Report
Prepared for
Maddocks Lawyers on behalf of
Lovely Banks Development Group

**Amendment C395 to the Greater
Geelong Planning Scheme**

traffic: evidence

Maddocks Lawyers on behalf of
Lovely Banks Development Group
Our reference 16658T-REP01-F01

Appendix B: Elcho Road Vertical Design:

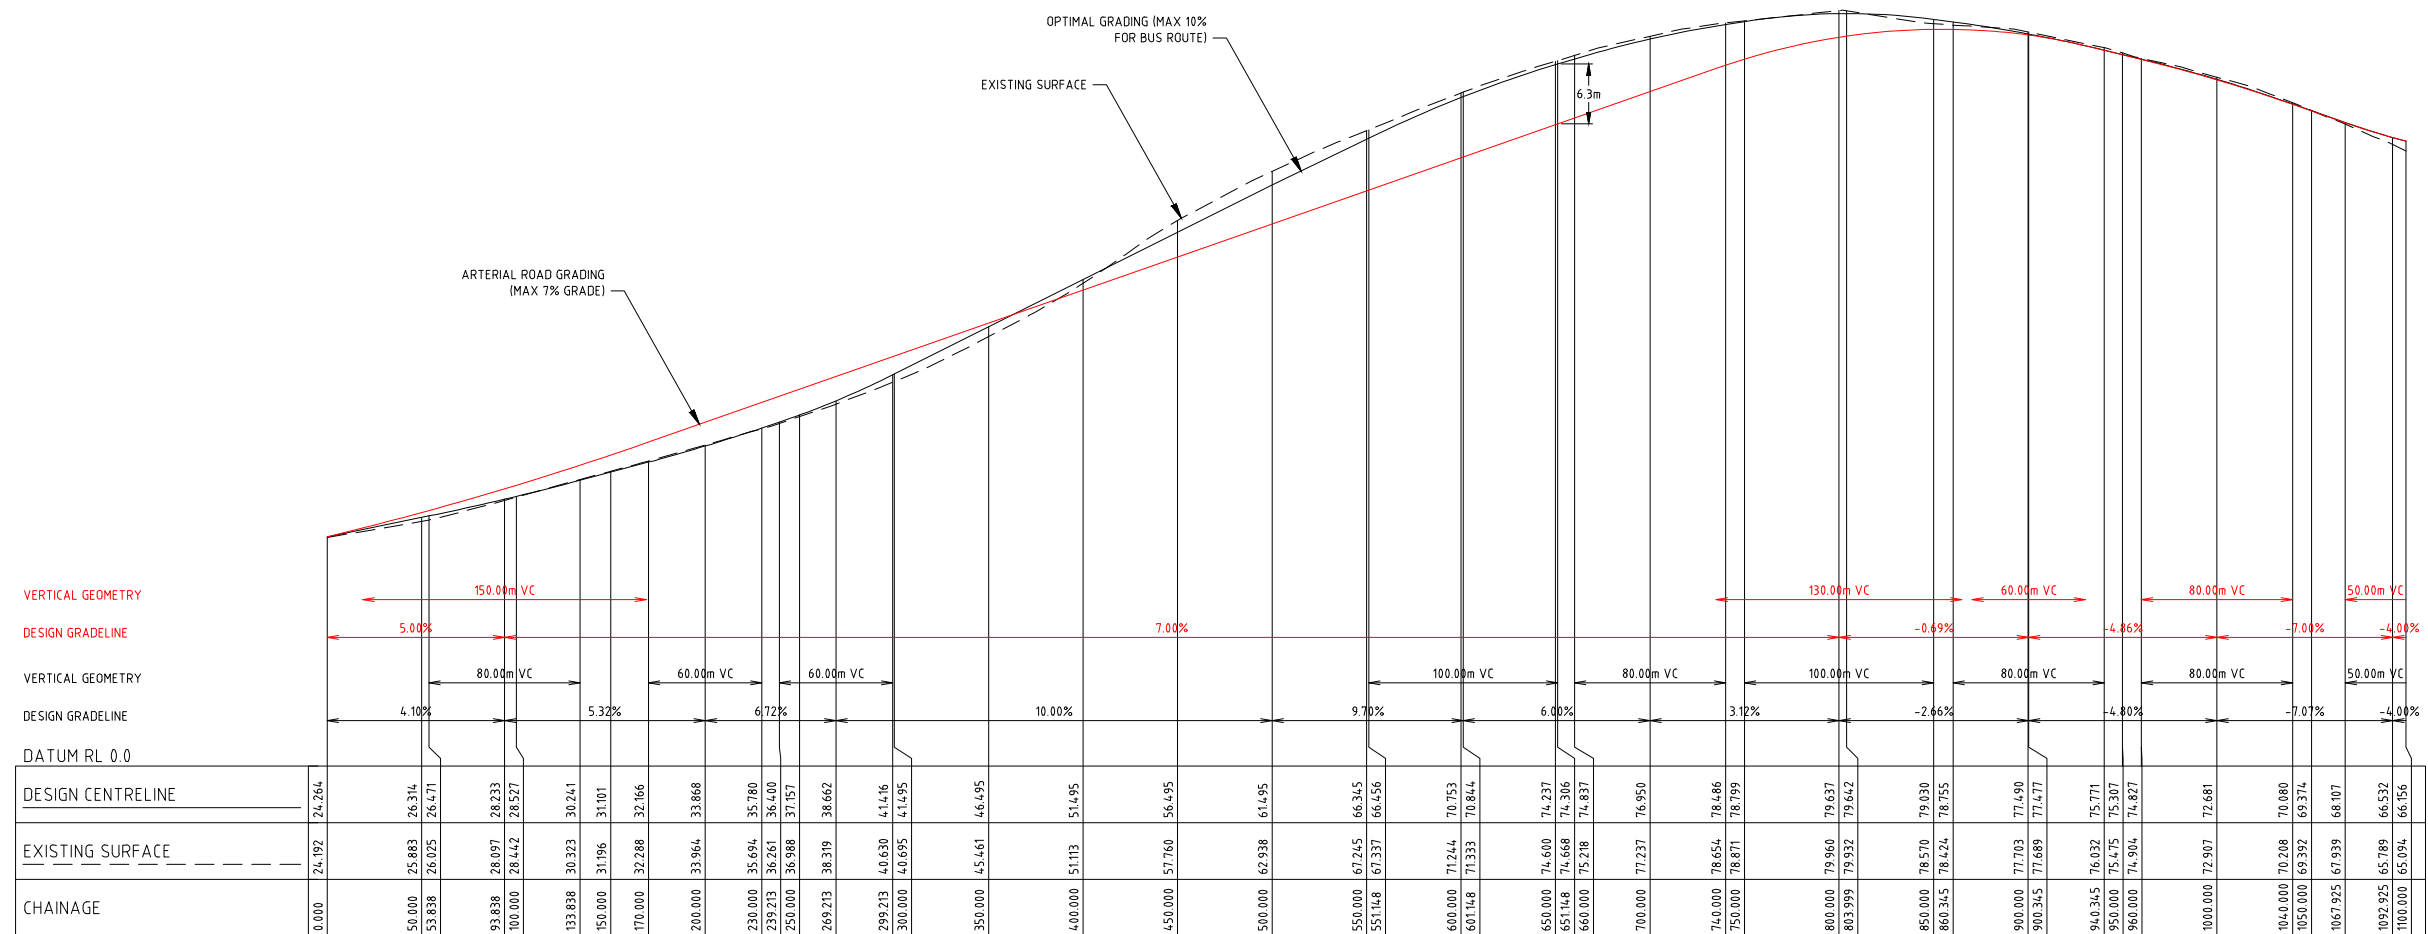
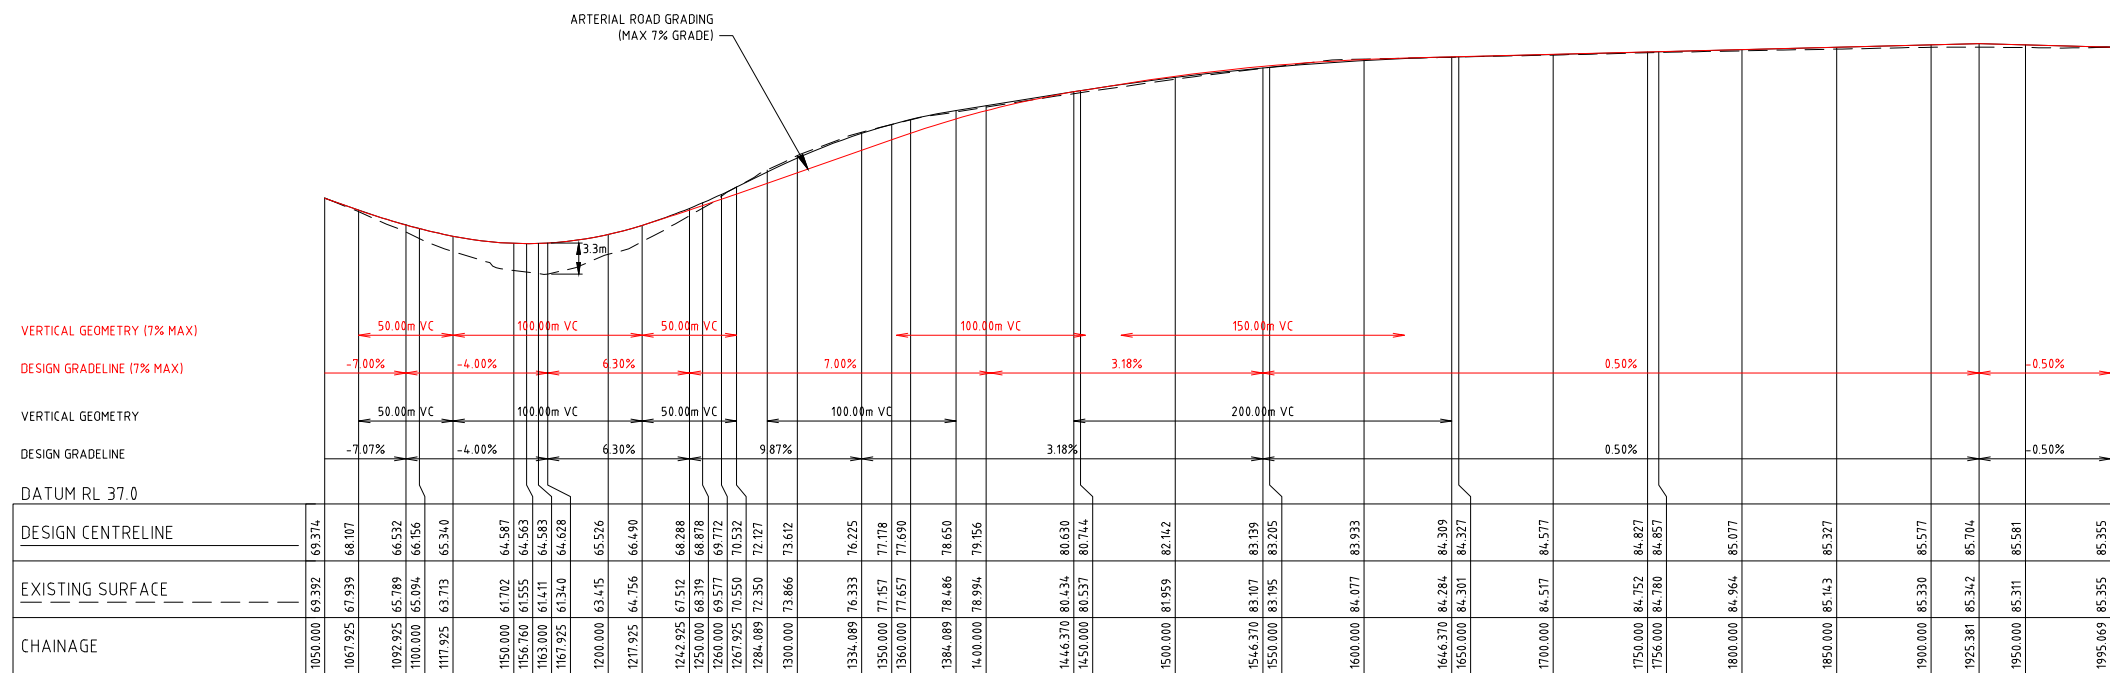
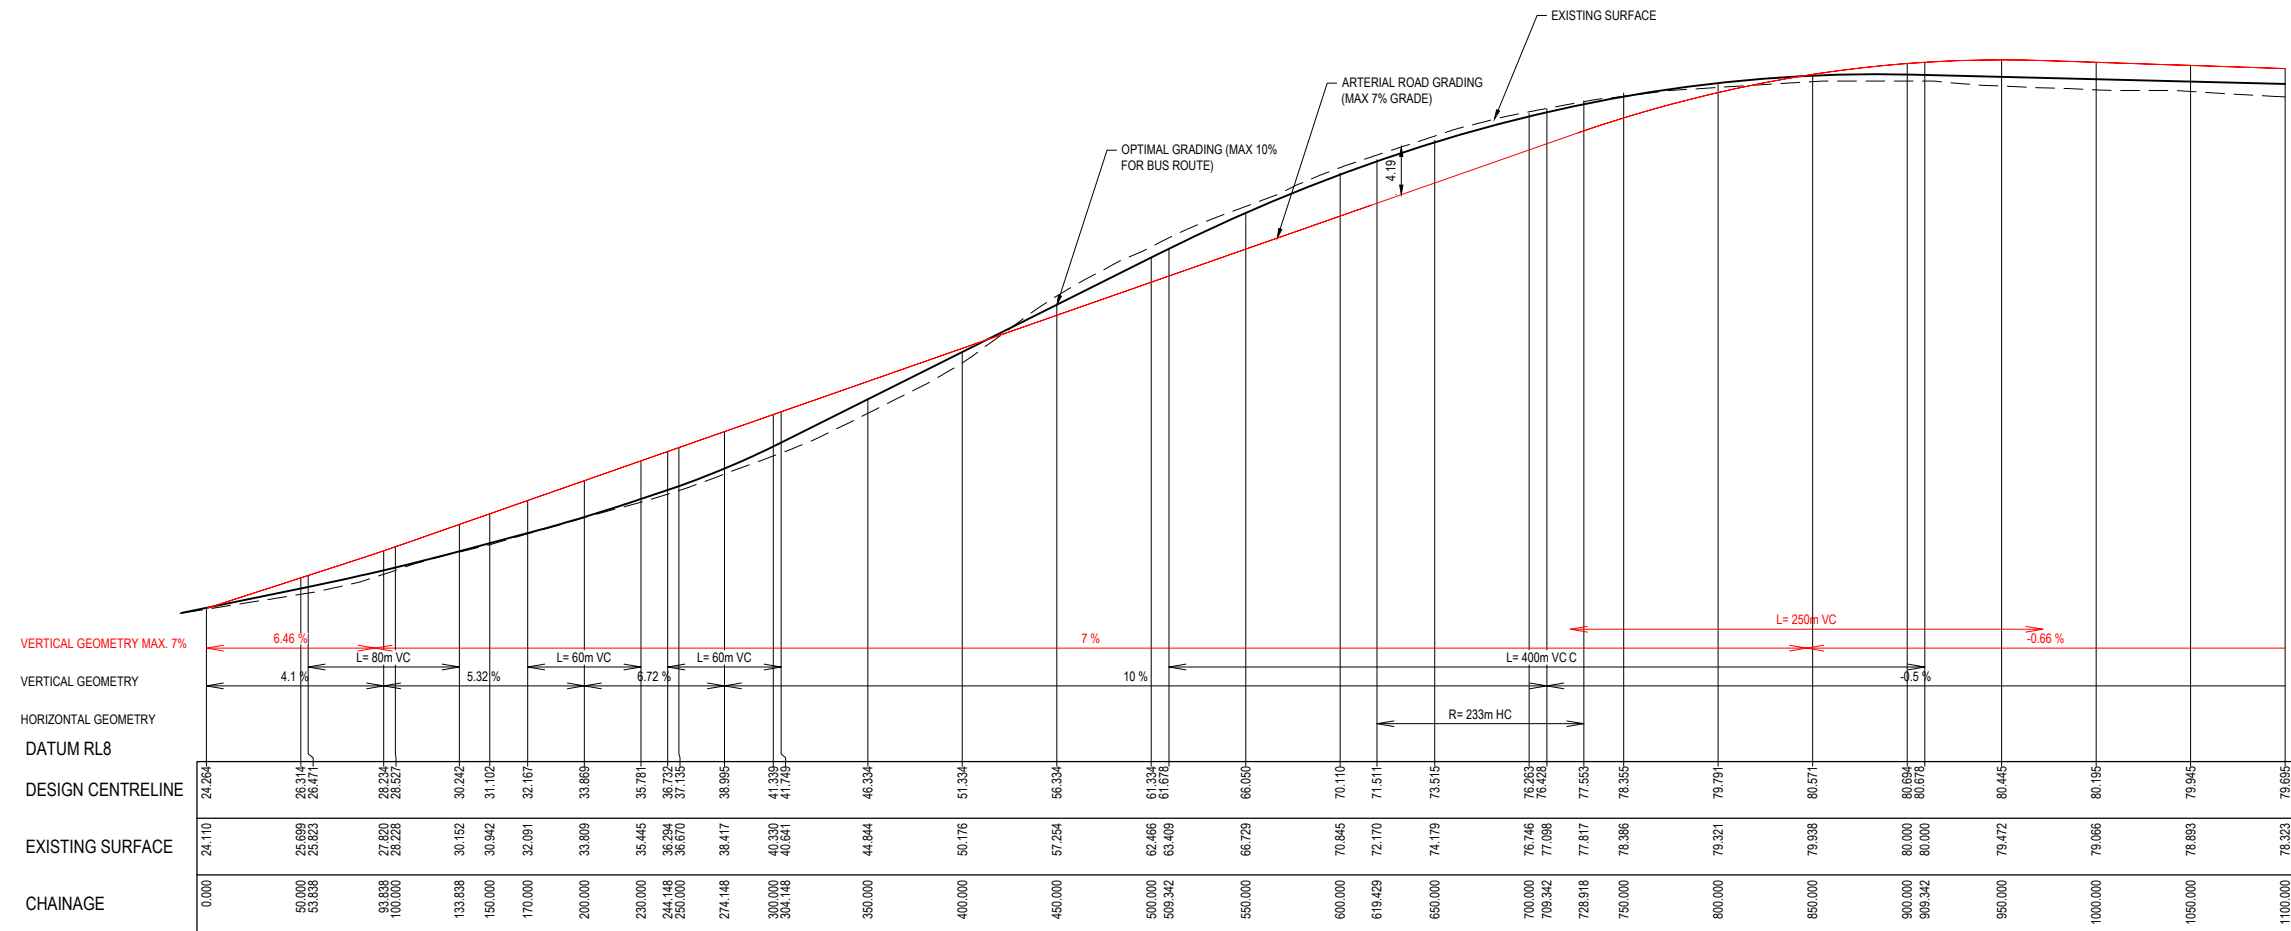
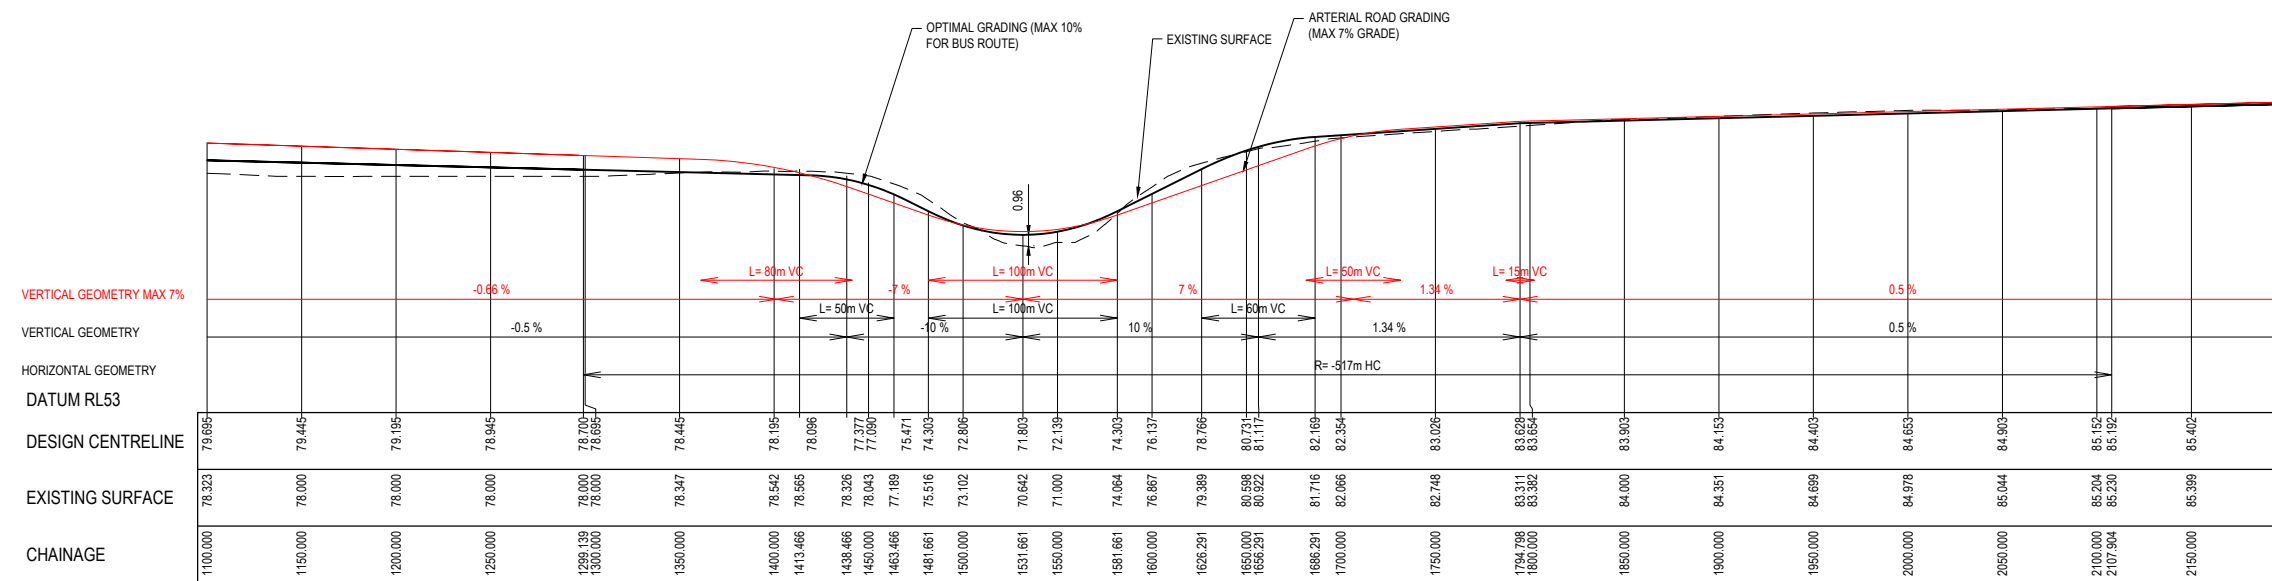
2. I have reviewed the grades adopted for vertical geometry as per the plans attached in Appendix B. The relevant reference documents for the vertical geometry of arterial roads is the Austroads Guide to Road Design Part 3 – Geometric Design and the VicRoads supplements to these guides. It specifies a maximum general gradient for roads with an operating speed of 80km/hr of between 4% and 9% depending on the terrain type. The Beveridge Williams plans have adopted designs based on a maximum grade of 7% which is within the permissible range.

3. An alternative design adopting a maximum gradient of 10% was also prepared, which I believe was understood to be in line with the desirable maximum grade specified in Table 4 of the *Infrastructure Design Manual*. I note that this is not the relevant design manual for arterial road design and is only applicable to the design of municipal roads. Notwithstanding, the Austroads Guide to Road Design, which is applicable to the design of arterial roads notes that the adoption of grades steeper than the general maximum (i.e. such as 10%) may be justified in certain situations as follows:

4. On the basis of the above, I would suggest viewing the design based on a 7% maximum gradient as a design that falls within published vertical geometry design parameters and the 10% design as being one that is potentially justifiable.
-
